MEMORANDUM

DATE: September 9, 2021
TO: Erin Holsonback, Otten + Associates Landscape Architects, Inc
FROM: Terrence P. Flanagan, ISA Board Certified Master Arborist, PN-0120BMTL
RE: Manhasset Tree Plan

**MANHASSET
INDUSTRIAL**

TREE PLAN

TREE PLAN

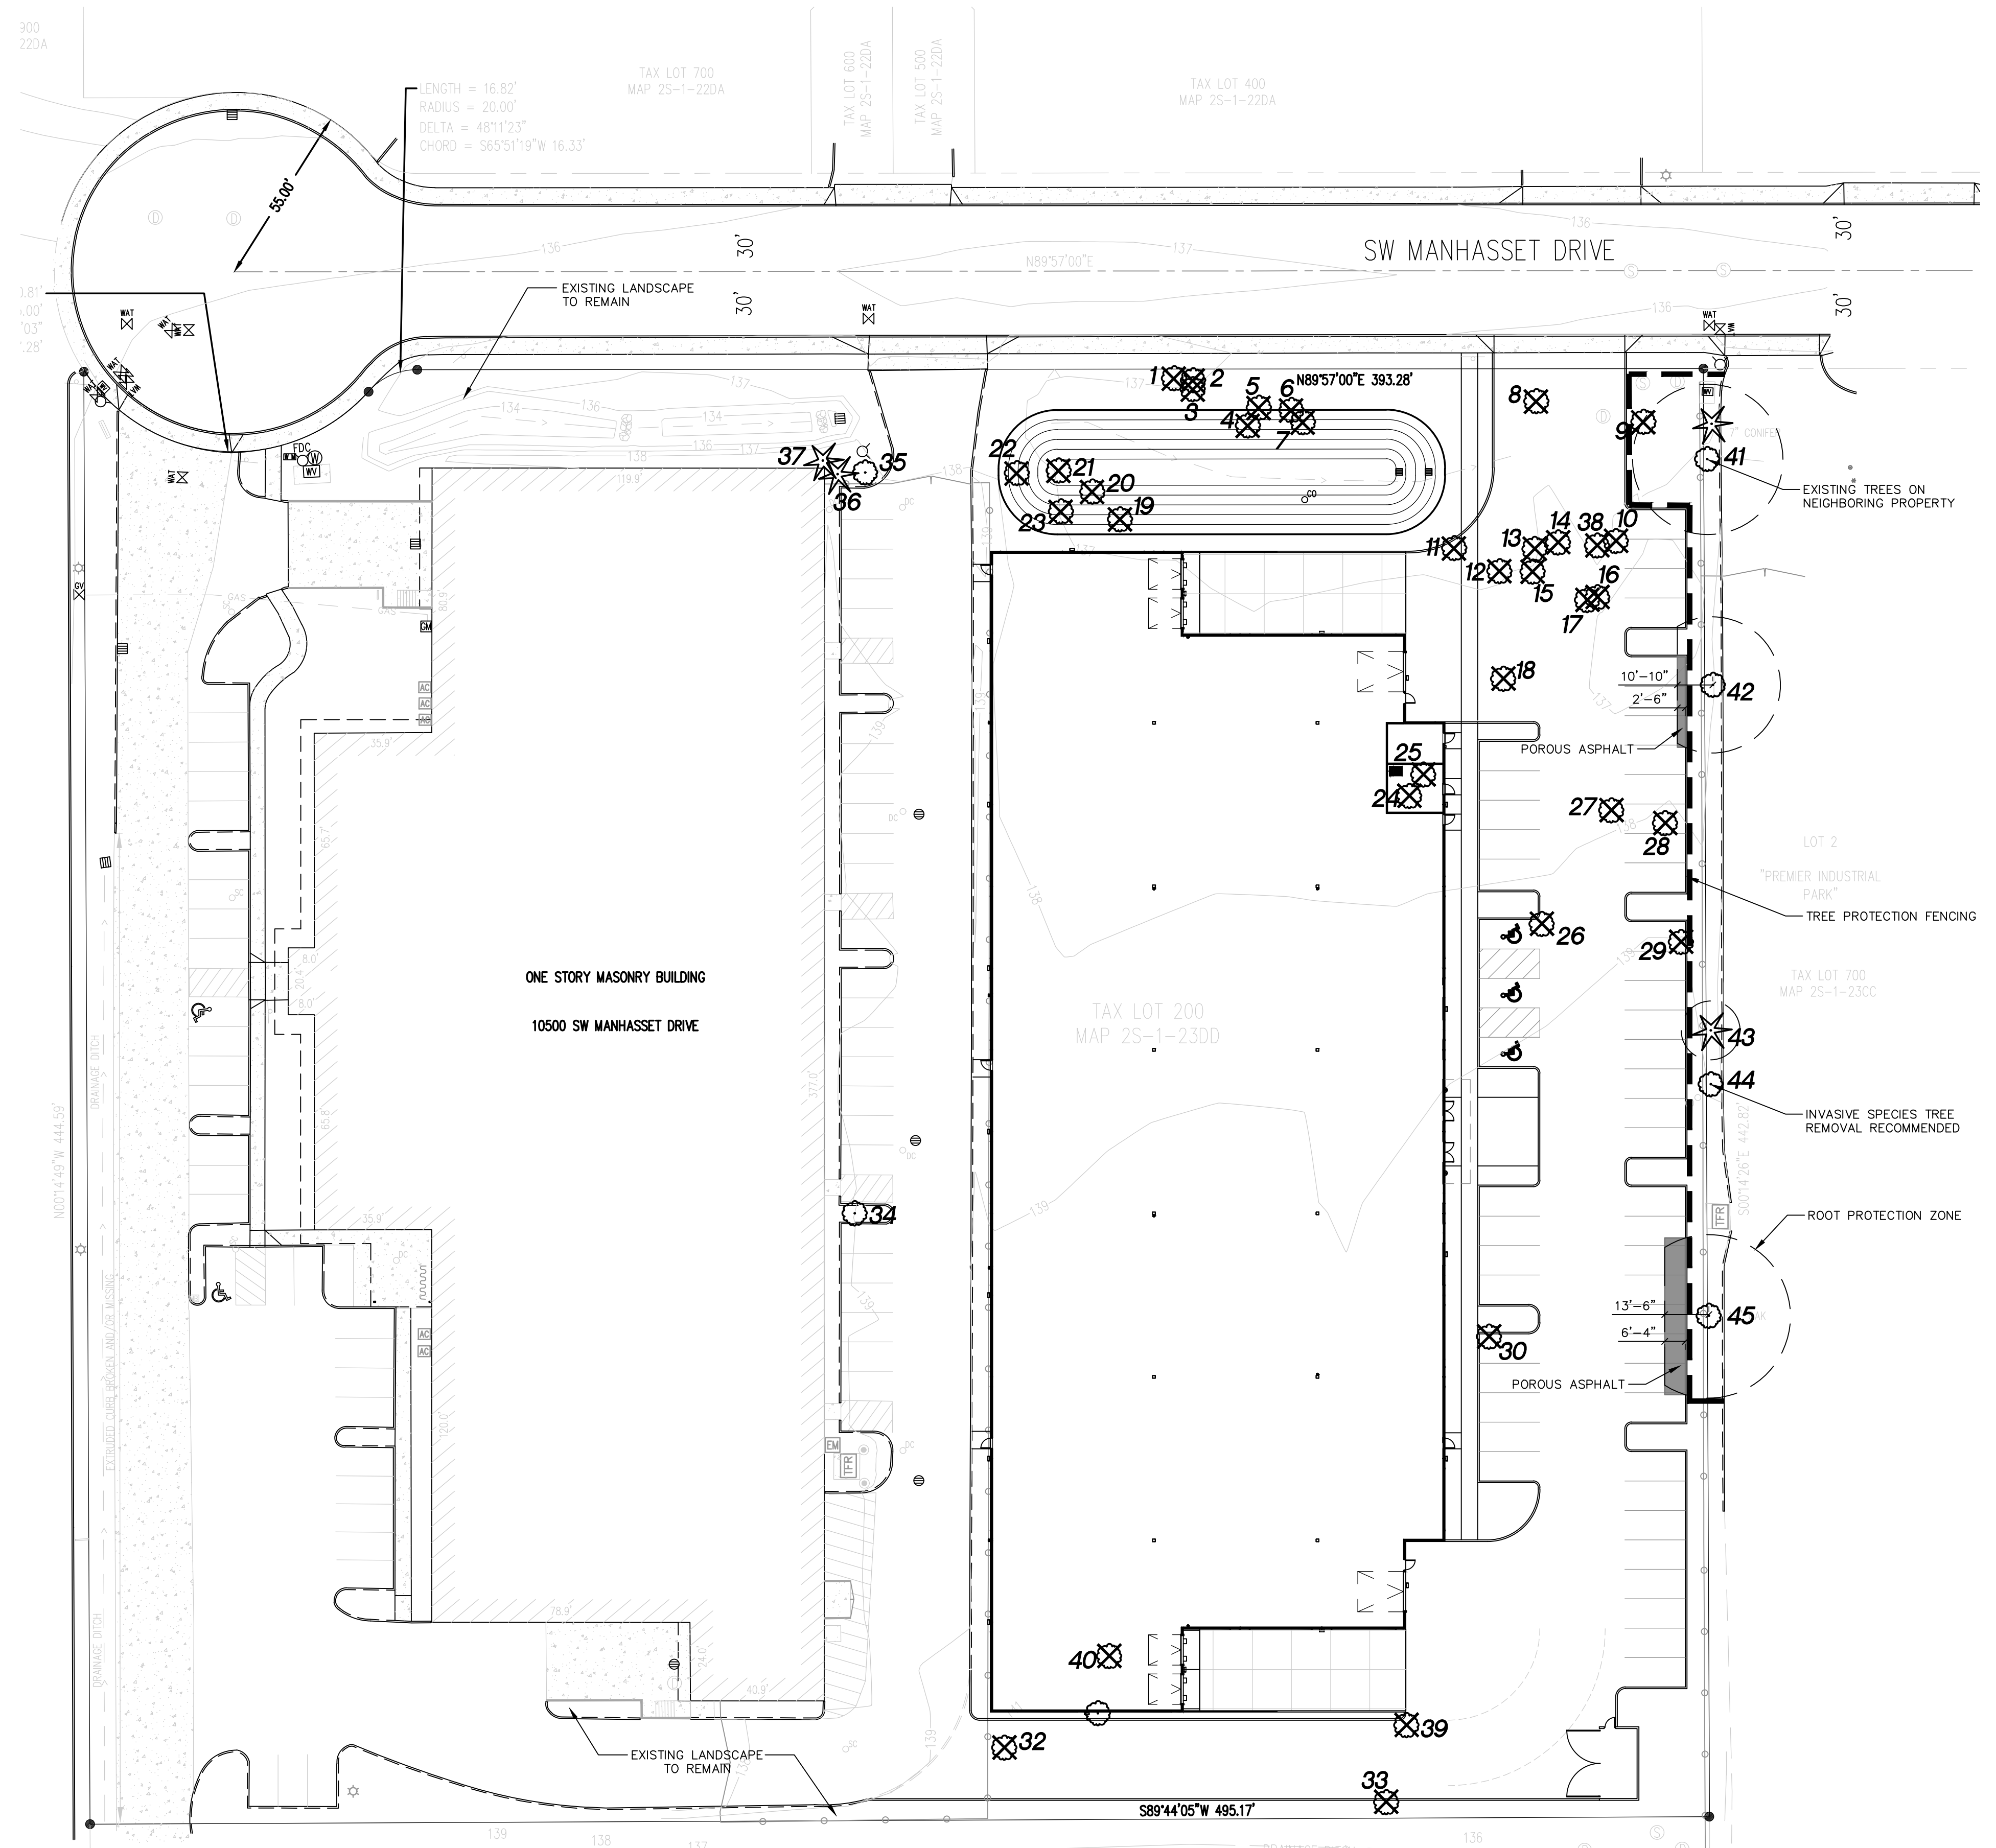
Erin Holsonback provided the site plan with trees marked for removal and the location of tree protection fencing as well as areas of pervious paving. All of the trees marked with X will have to be removed to accommodate the construction of the new building and paved areas.

The eastern neighbor's Oregon white oaks (*Quercus garryana*) will be protected during construction from long term impacts by the erection of the tree protection fence whose location is shown on the site plan. In addition, oak number 42 and 45 will have areas of pervious pavement placed just east of the of the trees with no curbs to prevent the need to cut roots and allow moisture to reach the roots of the oaks in the areas of the protected tree rooting protection zone. On the site plan, those areas are shown as greyed out and should be treated as extensions of the tree protection areas. No cut or fill beyond four inches shall be allowed within the tree protection areas or areas that are to have pervious pavement nor shall the area have the soil compacted. If a curb of some type is desired, an asphalt curb or concrete parking stop could be placed on top of the pervious pavement. Either pervious asphalt or concrete can be used with the idea that the base would be no deeper than four inches thick placed on top of the existing soil with the duff layer removed. No soil cut shall be allowed. As the pervious payment is only to be placed at the end of the parking stall, it shouldn't have to support too much weight as only the vehicle's front or rear end will have to be supported.

On the site plan, the area of protected tree rooting protection is shown as extending onto the neighboring property. It should be understood that there should be no need to extend any tree protection fencing onto the neighboring property and only in the areas where the fence is shown on the plan.

All of the trees marked with X on the site plan need to be removed to accommodate the construction of the new building.

The location of the tree protection fencing should adequately provide protection to the trees long term as long as the areas where pervious pavement is to be placed has no excavation or fill greater than four inches.
